Patent Application:  
X-ray anode and Process for its Manufacture

Applicants :	Matthias FRYDA et al.	)	
		)	Group Art Unit: 2882
Appln. No. :	10/030,133	)	
		)	Examiner: I. Kiknadze
Filed :	January 25, 2002	)	
		)	
For :	X-RAY ANODE AND PROCESS FOR ITS MANUFACTURE

## AMENDMENT UNDER 37 C.F.R. 1.111

Fig. 1

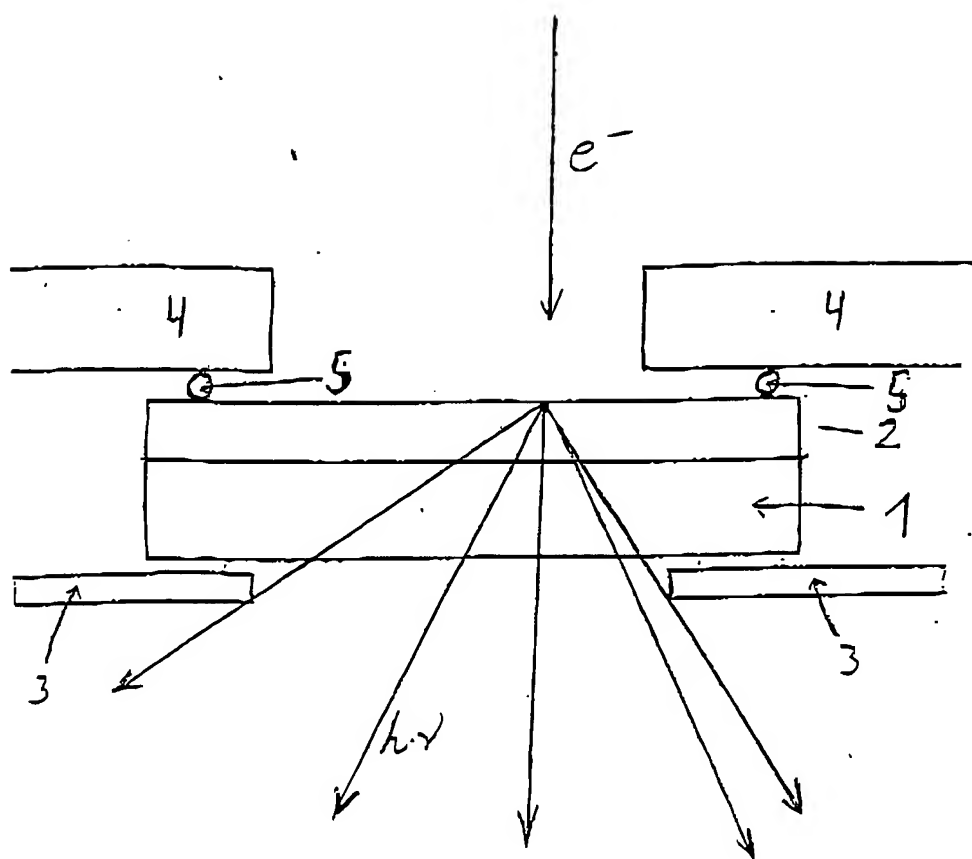
In the Replacement Drawing Sheet showing Fig. 1, reference number 5 has replaced reference number 4. Applicant submits that no new matter has been added to the drawings.

Applicant appreciates the courtesy extended by Examiner Irakli Kiknadze in the interview of August 26, 2003. In that interview, Applicant's representative discussed, among other things, amending Fig.1 to show that the sealing washer is represented with reference number 5 and that the specification would be amended consistent with this change.

*Please replace the drawing sheet illustrating Fig. 1 with the "Replacement Drawing Sheet" attached to the end of this Amendment:*
